**AGENDA
PLANNING COMMISSION
CITY OF WYOMING, MINNESOTA
DECEMBER 28, 2021
7:00 PM**

TO: Planning Commission
FROM: Tom Ramler-Olson, City Planner
Fred Weck
MEETING DATE: December 28, 2021
RE: Preliminary Plat Review
APPLICANT/OWNER: Beckmann Custom Homes, LLC
PROPERTY: PID R21.00040.01, R21.00040.02, R21.00040.03,
R21.00040.04, R21.00040.05, R21.00040.06
FILE NO.: D-21-010

Re: Preliminary Plat Review
Diamond Ridge – Emerald Avenue
WSB Project No. 016476-000

DIAMOND RIDGE - EMERALD AVENUE

DIAMOND RIDGE - EMERALD AVENUE
BRINKMANN CUSTOM HOMES
WYOMING, MN
GRADING PLAN

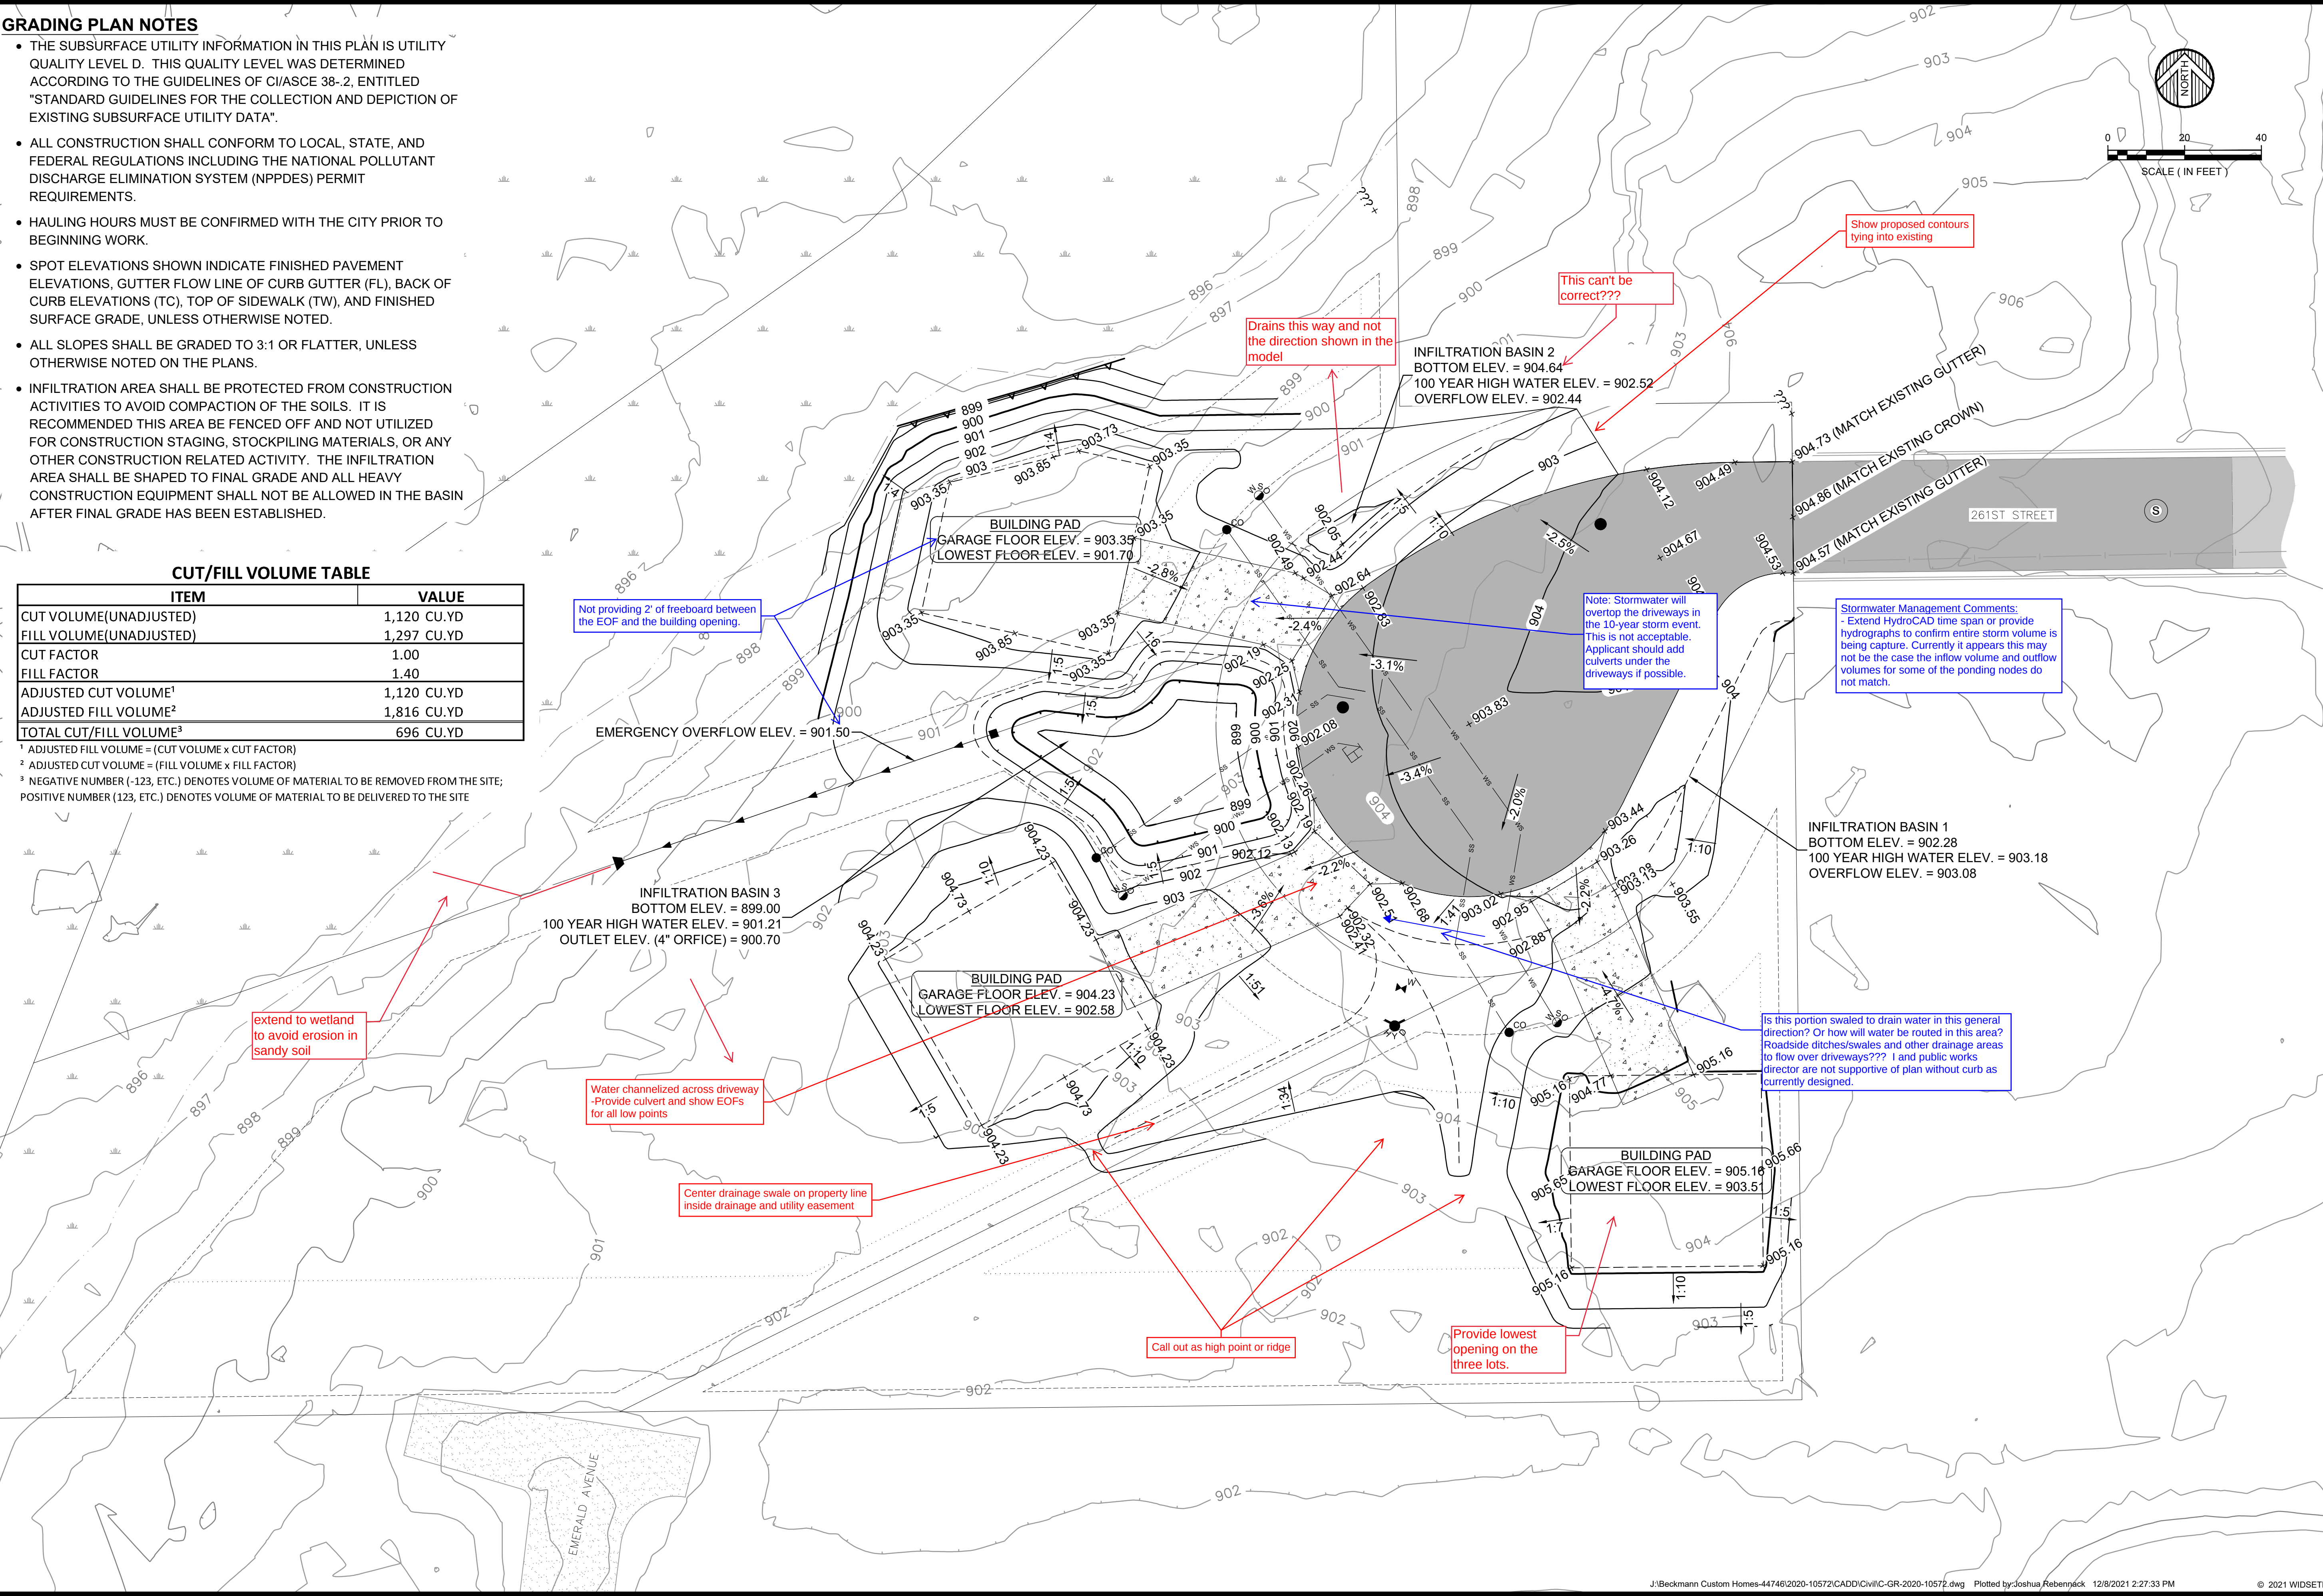
The applicant has not included a grading plan, but rather linework of the swale bottom and side slopes that follow the perimeter of the pond. It appears the swale will carry around the cul-de-sac and discharge into the wetland at the northern portion of the cul-de-sac. If the swale was at 1% grade the swale would be deeper at the outlet side by greater than 2-foot and the linework shown would not be reflective of what the grading would actually look like. The grading plan should also show the outlet swale adjacent to the neighboring property to ensure there are not impacts to this adjacent property. *Revised plans have been submitted.*

Building type (slab on grade, look out, walk out, full basement) should be identified on the grading plan along with appropriate elevations to ensure adequate freeboard is provided from the 100-year high water level of adjacent wetlands. *This has been provided.*

DIAMOND RIDGE - EMERALD AVENUE
BRINKMANN CUSTOM HOMES
WYOMING, MN
UTILITY PLAN & PROFILE

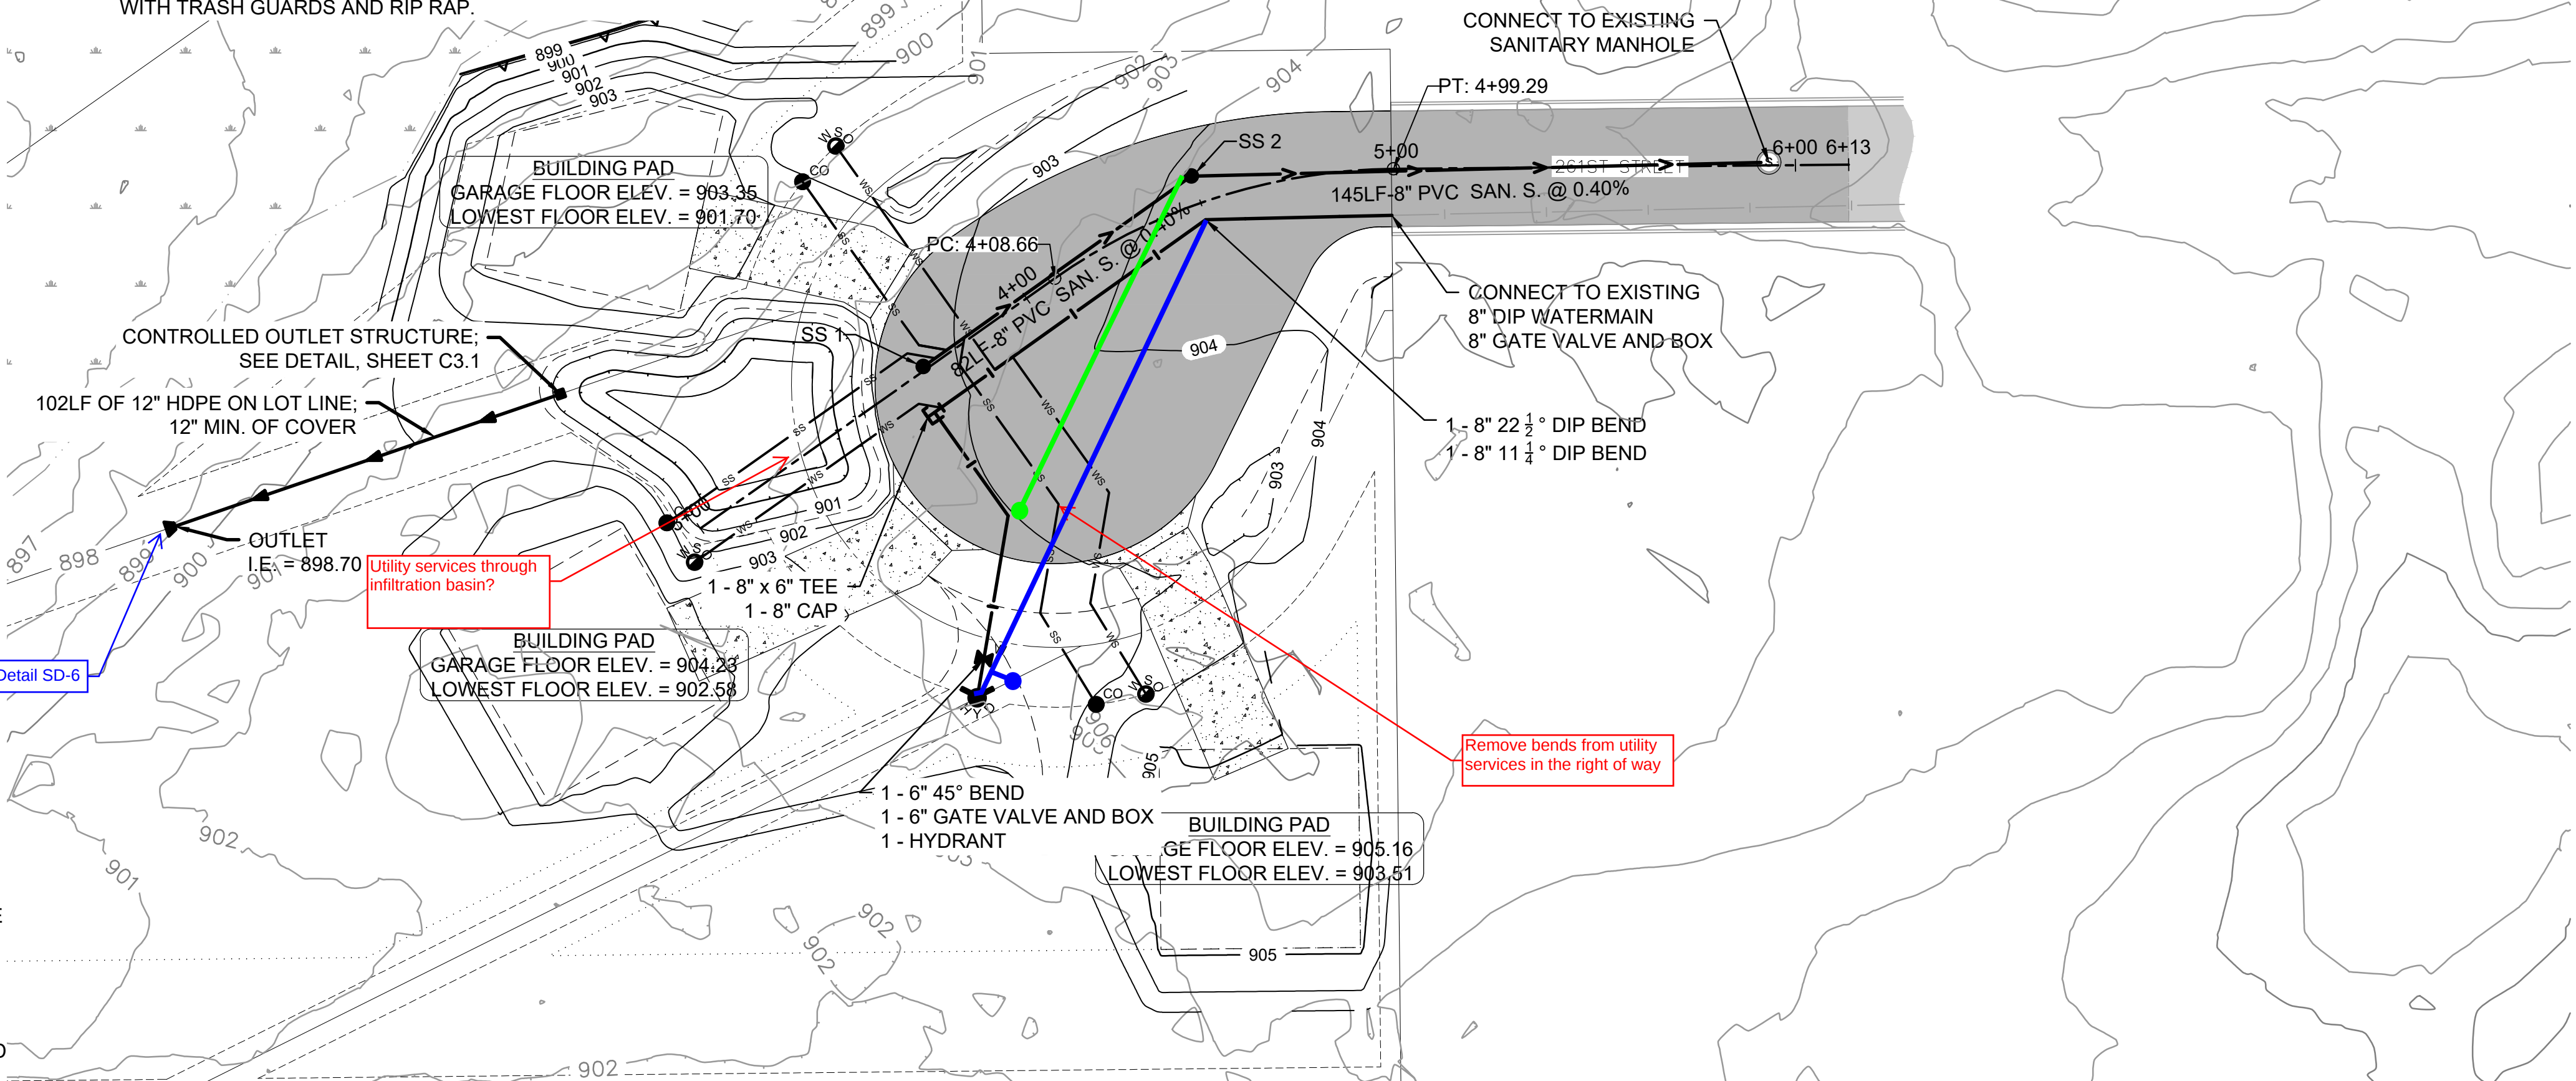
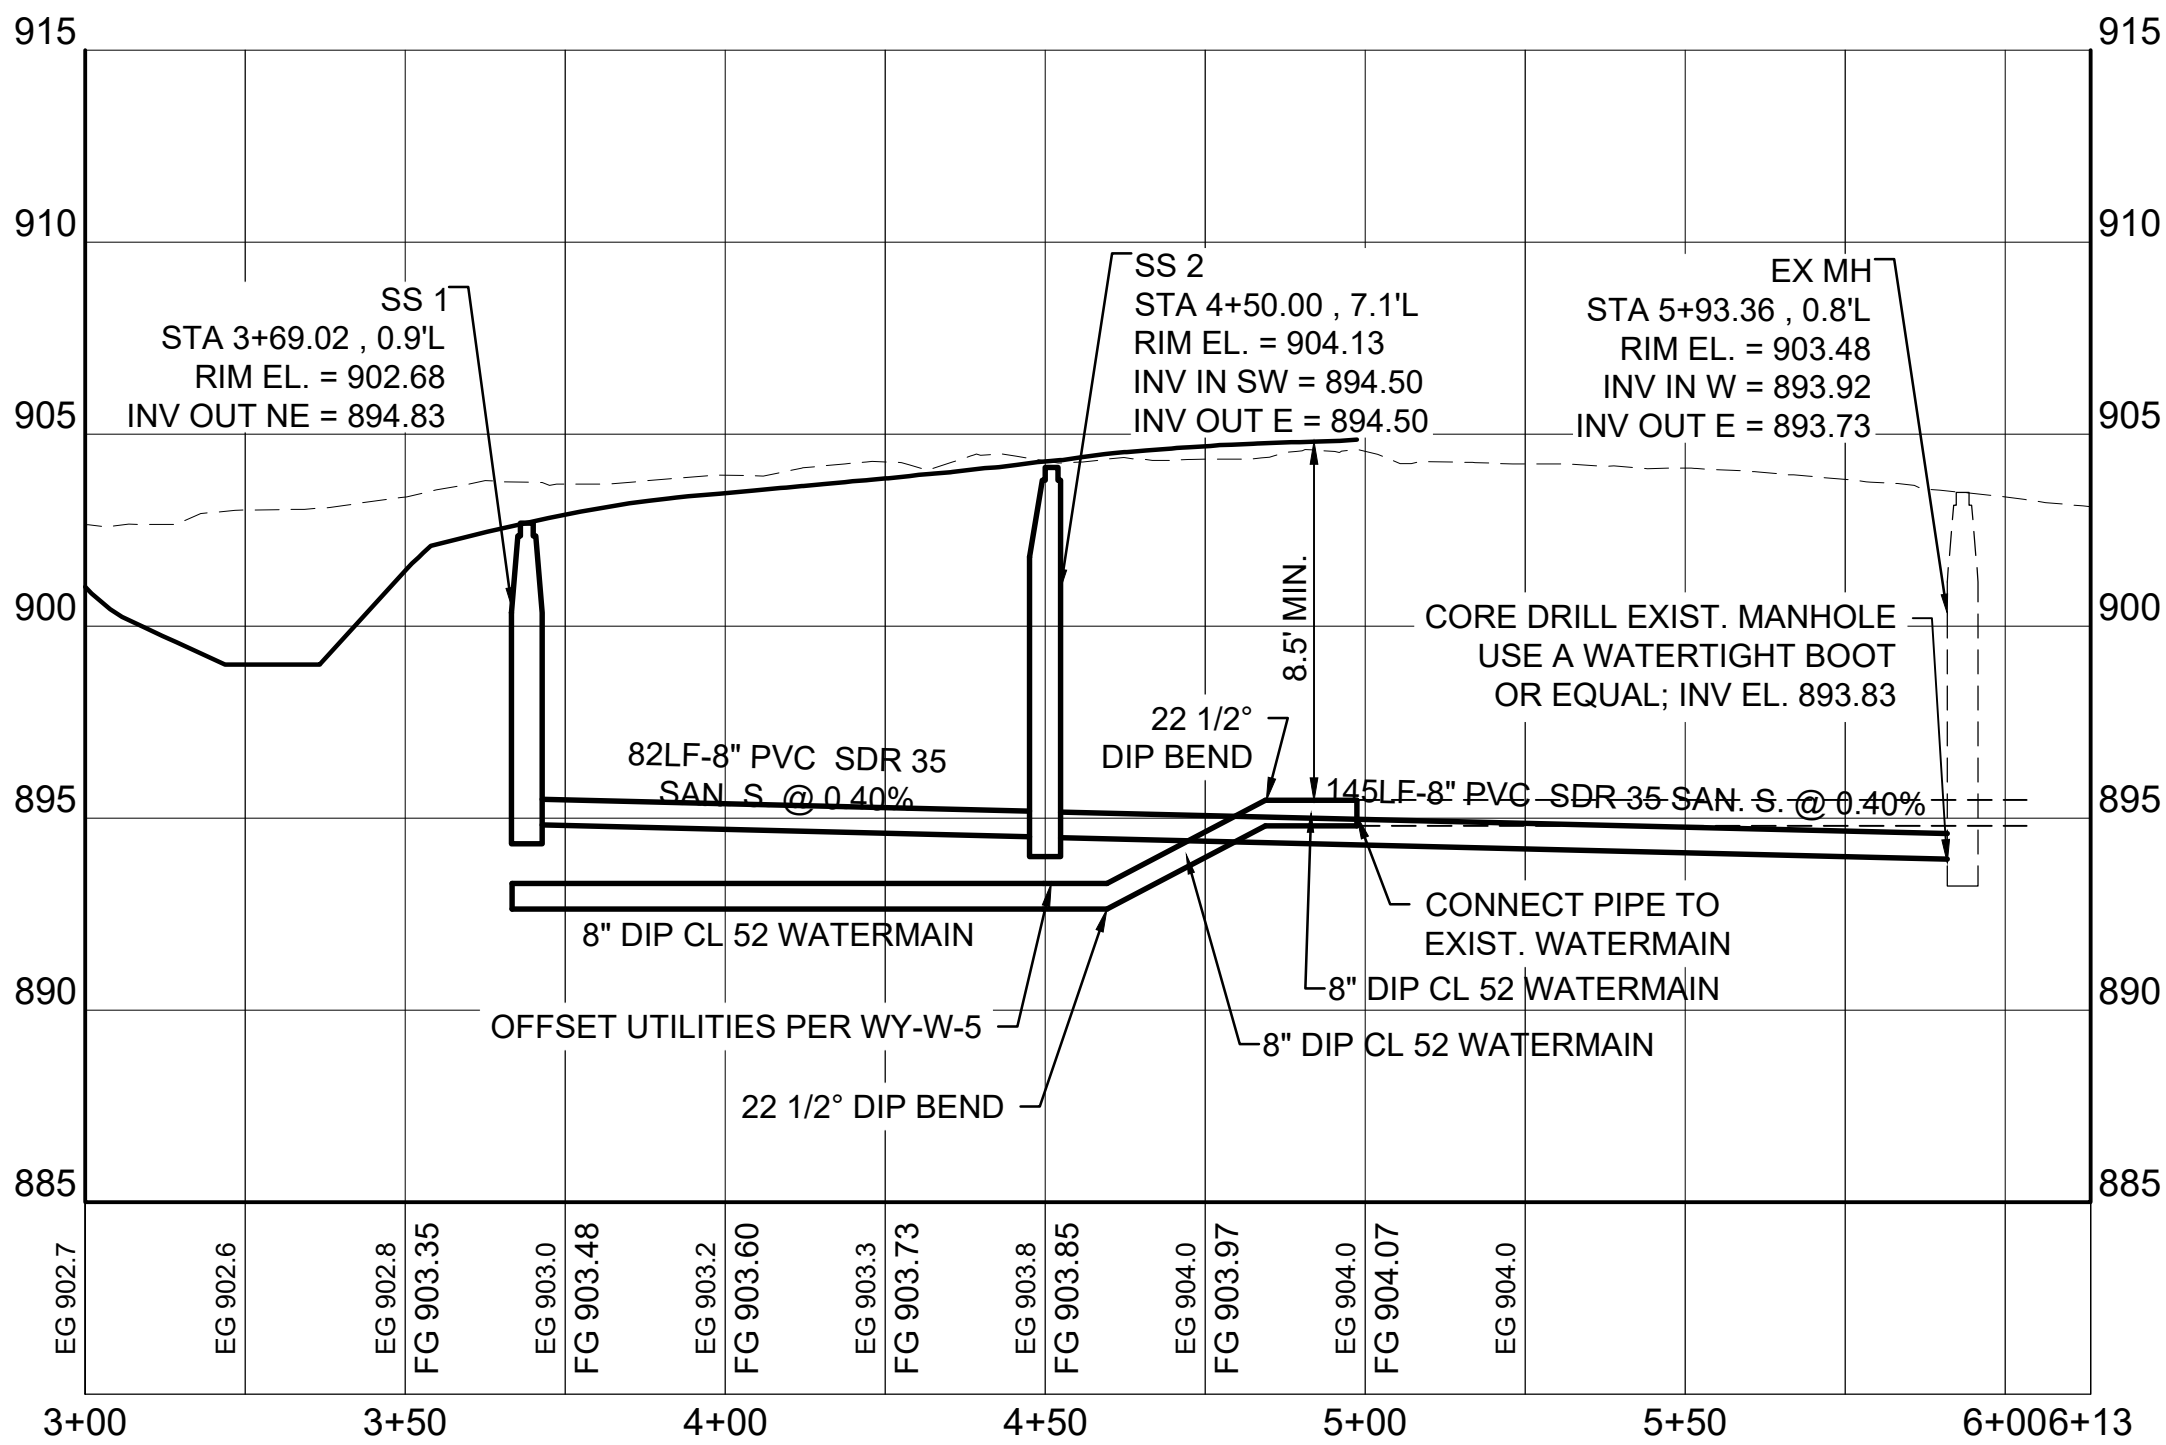
- THE CONTRACTOR SHALL RECEIVE THE NECESSARY PERMITS FOR ALL WORK OUTSIDE THE PROPERTY LIMITS. [Add riprap per City Detail SD-6](#)
- COORDINATE SERVICE LOCATION ENTRIES WITH THE MECHANICAL ENGINEER.
